# Colston Budd Rogers & Kafes Pty Ltd

10 July, 2018

## **RE: SECTION 4.55 APPLICATION FOR BENNETTS GREEN BUNNINGS AND BULKY GOODS DEVELOPMENT**

12.5m LARGE RIGID VEHICLE  
SWEPT PATHS

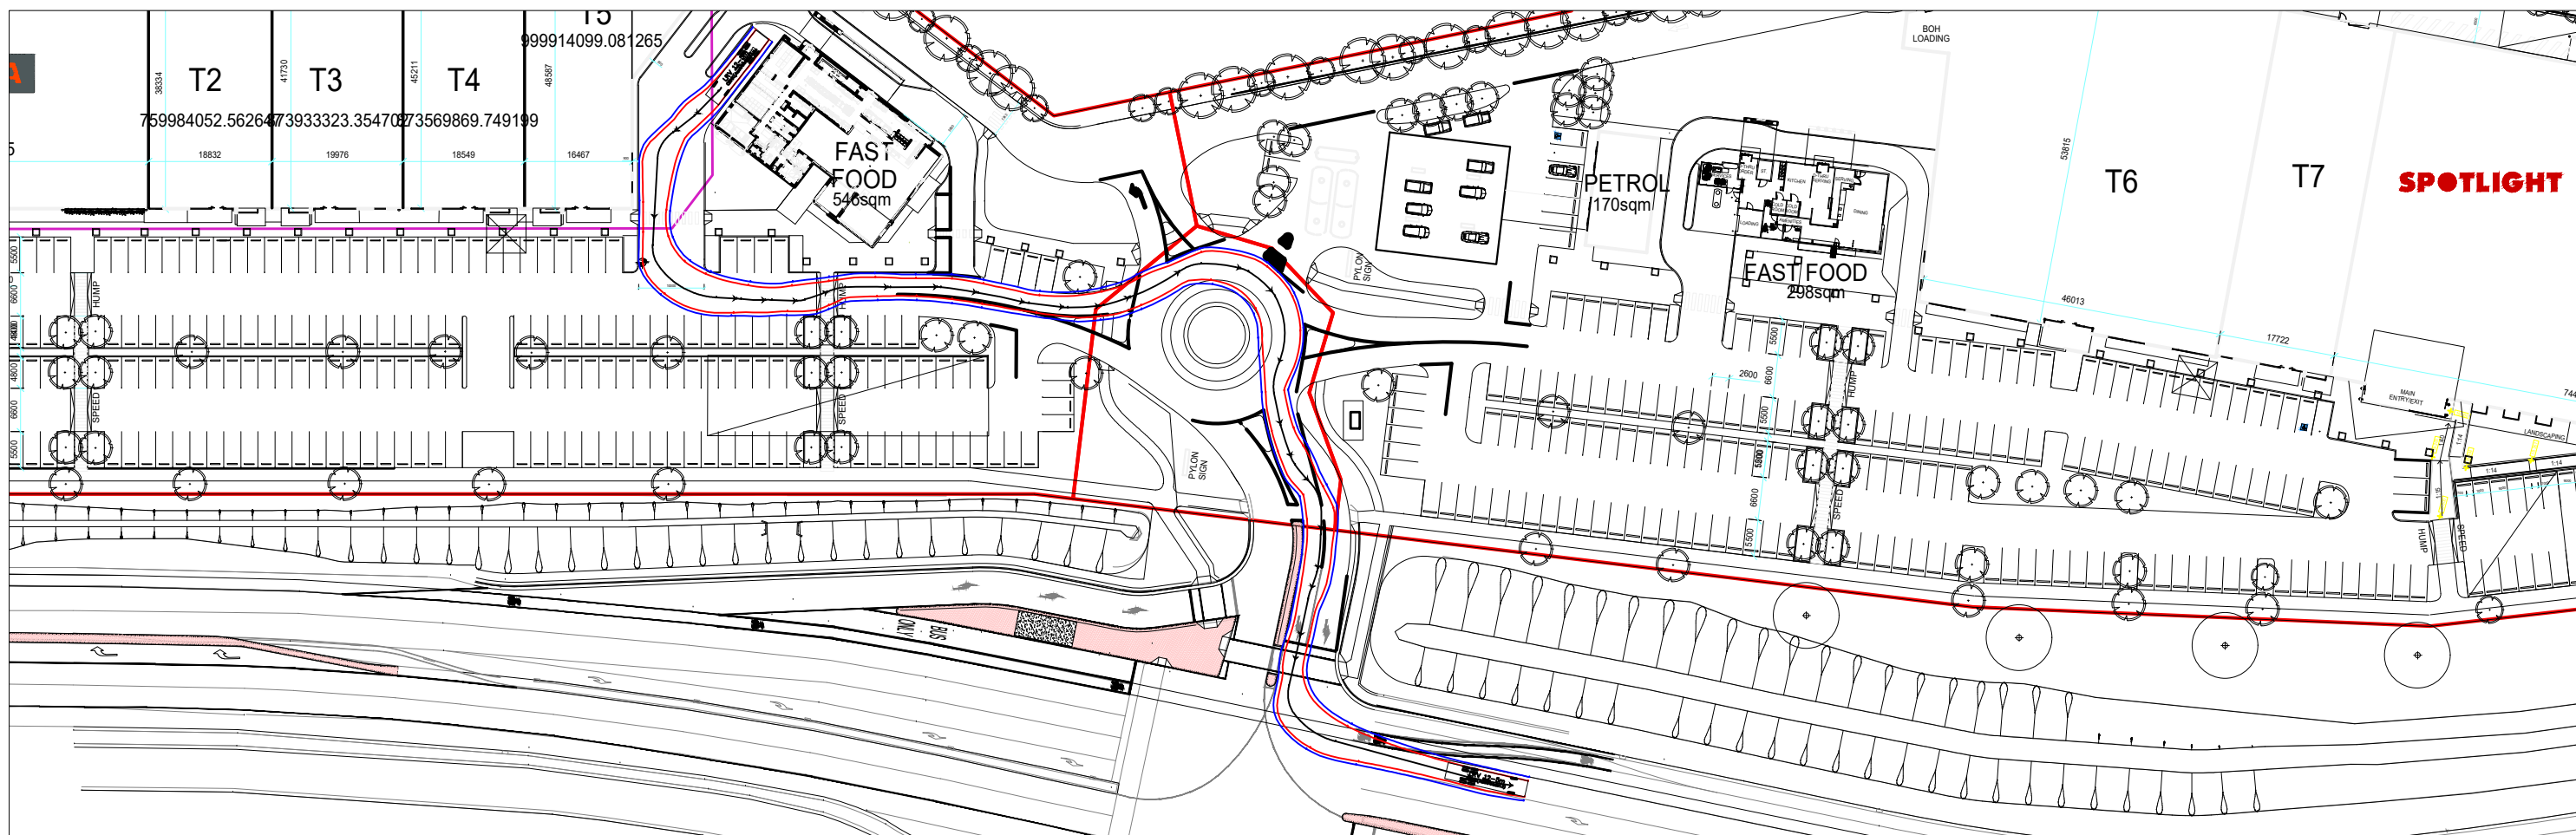
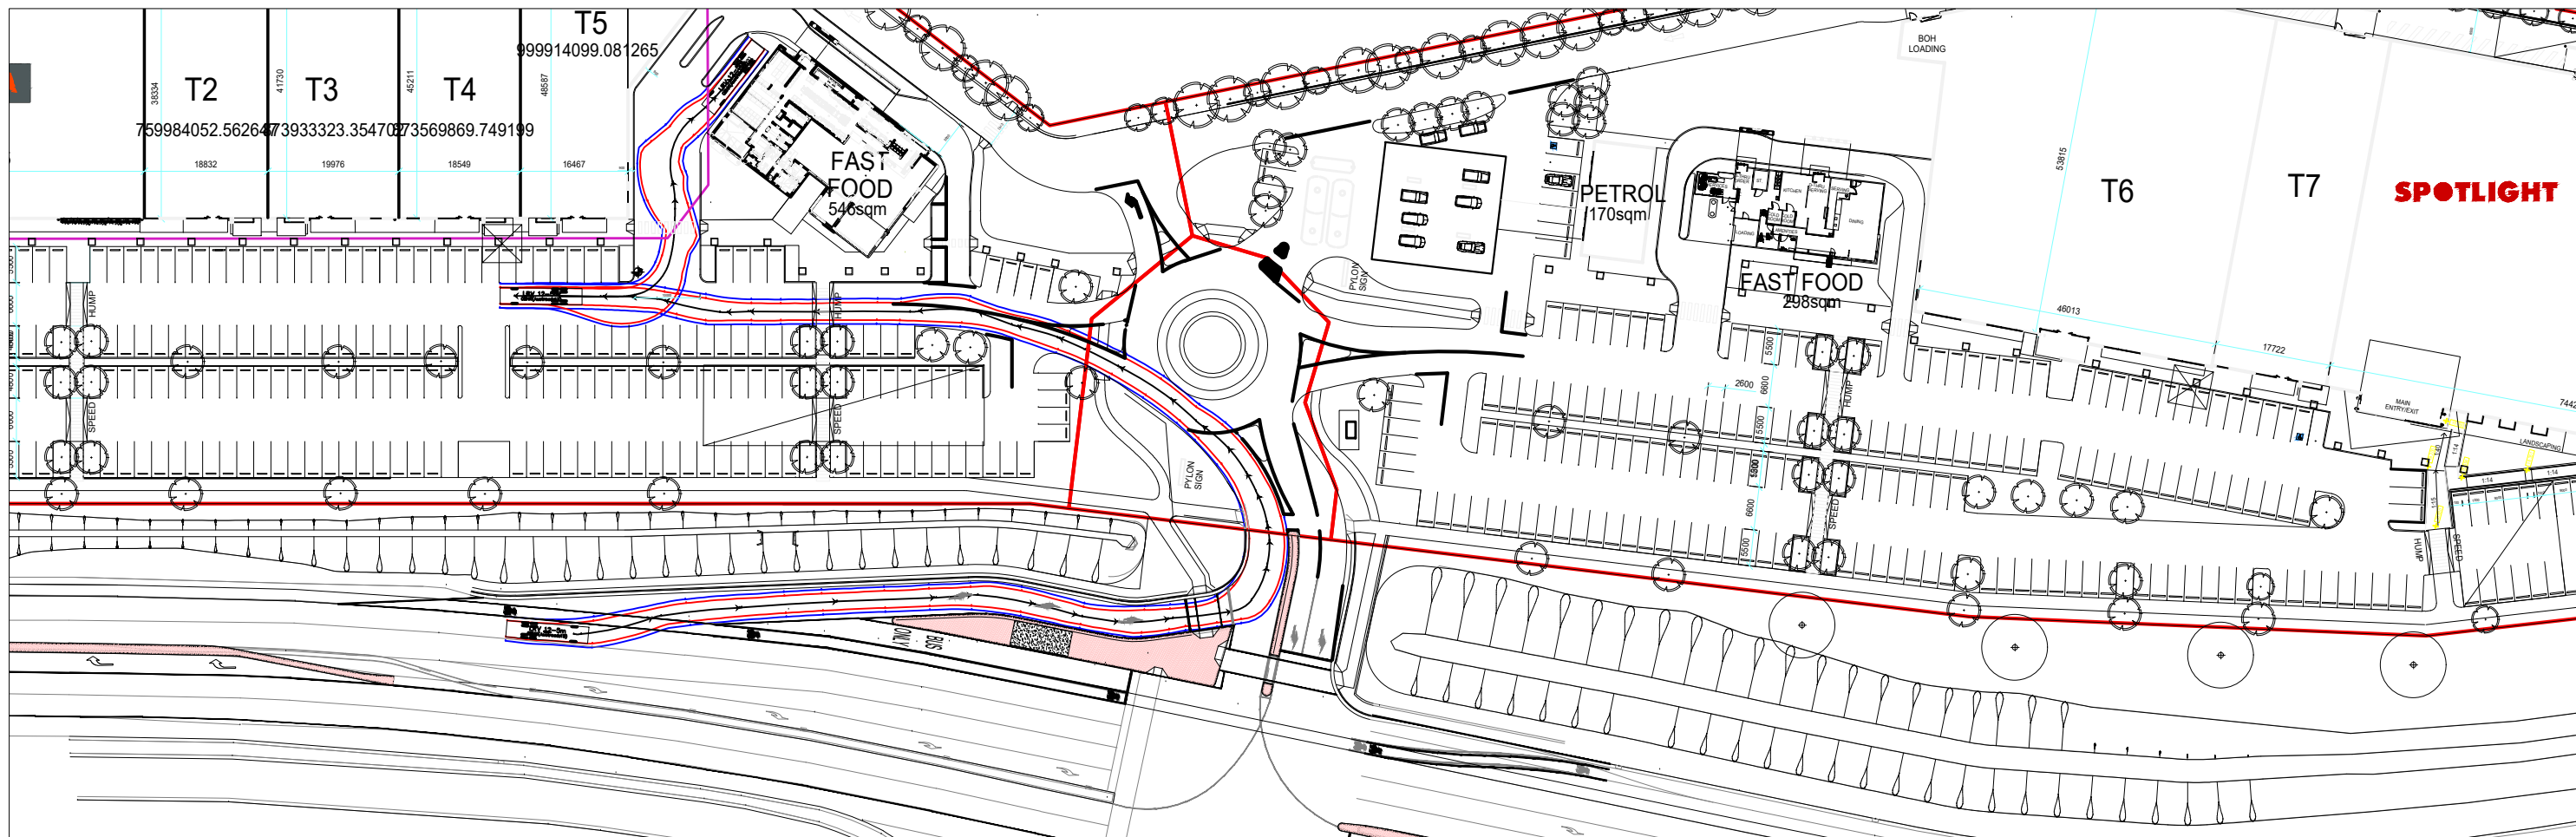
*There is potential for conflict between the swept paths for delivery vehicles for the bulky goods units operating along the service road, the swept paths for the fuel tanker for the Service Station, swept paths for vehicles accessing the fast food drive thru and swept paths for vehicles accessing the fuel bowzers. Further detail/analysis is required regarding peak operational and delivery times to demonstrate the likelihood of conflicts occurring and flow on effects impacting on the operation of the roundabout (and queuing) off Groves Road is required.*

23. Figures 5 and 8 show that service vehicles in the service road will not be affected by vehicles making deliveries at the rear of the various tenancies.

24. Figures 6 and 7 show swept paths of trucks accessing the fast food outlet loading docks. In order to manage potential conflicts between vehicles reversing into these docks and the operation of the drive throughs, a loading dock management plan (LDMP) would be prepared, noting that the number of deliveries to fast food outlets is typically low at one or two per day. This could be included as a condition of consent requiring preparation of the LDMP prior to the issue of a construction certificate for the fast food outlet. The LDMP would include measures such as:

**12.5m LARGE RIGID VEHICLE  
 SWEEP PATHS**

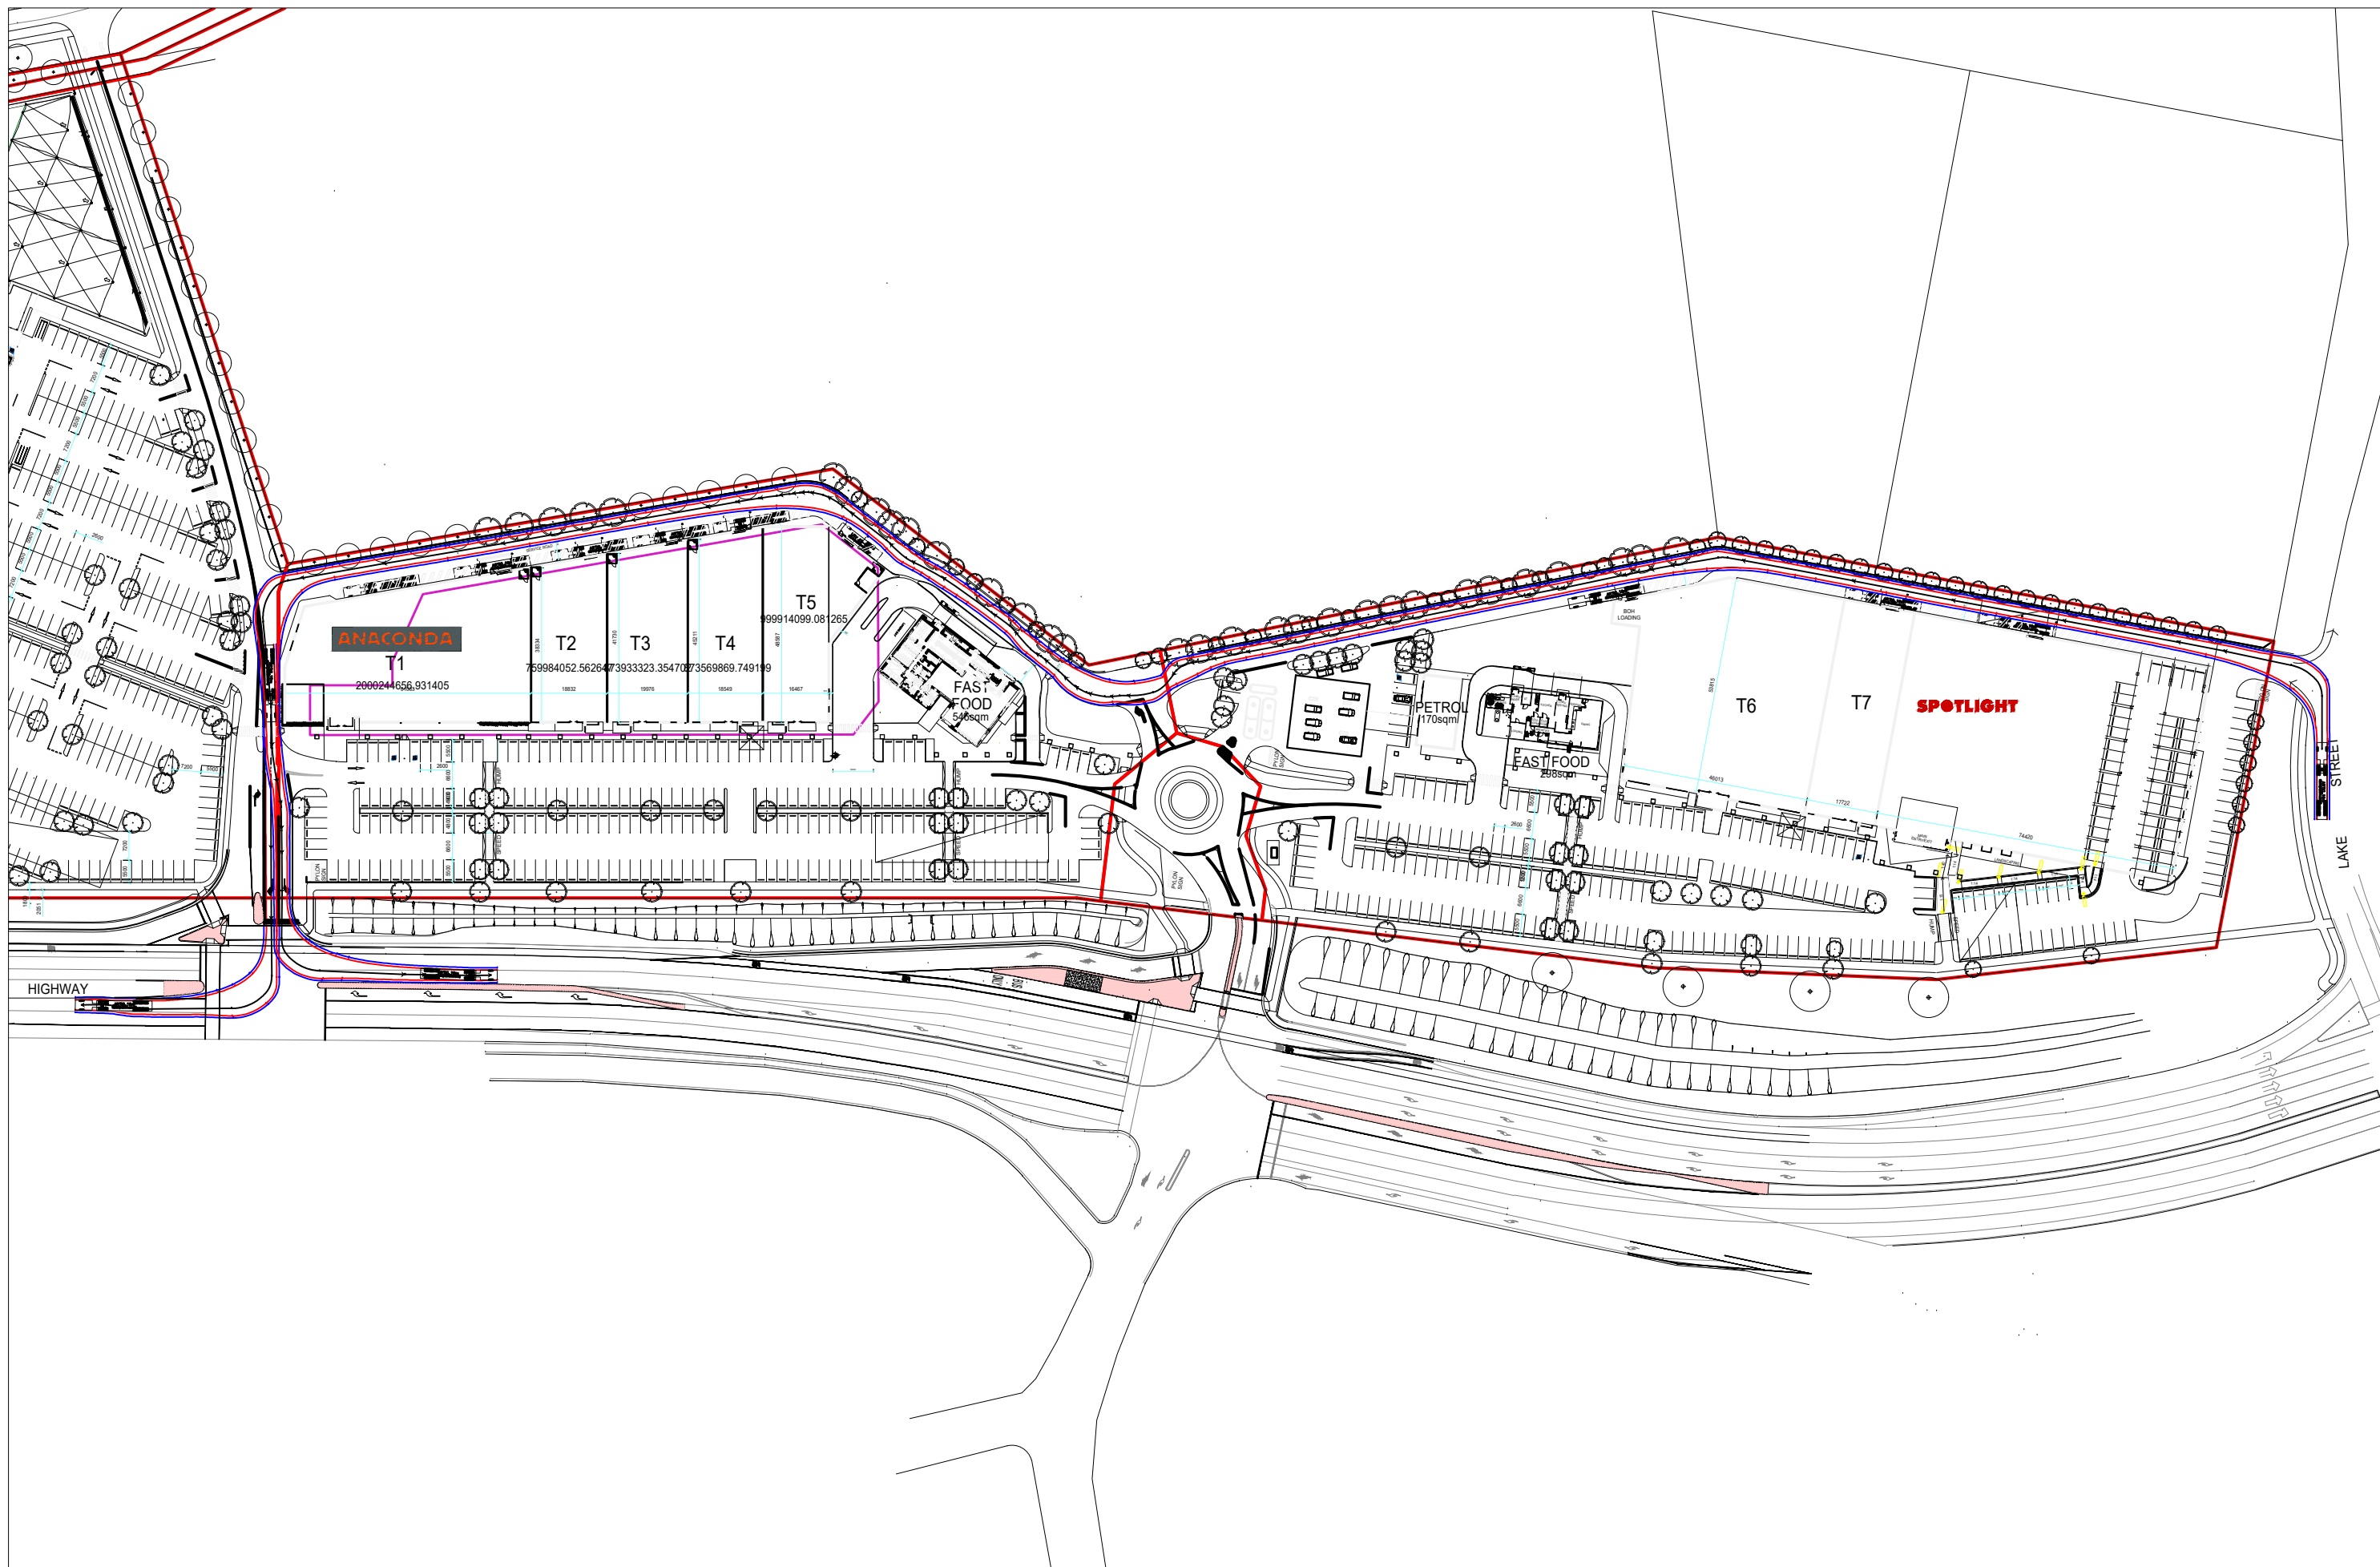
*Discussions with the RMS in relation to access off the Pacific Highway are noted. Should a revised access arrangement be proposed, this may affect the exit path of service vehicles associated with Service Station and Take Away Food & Drink Premises.*

25. Exit paths for these service vehicles are shown in Figures 5 to 10.
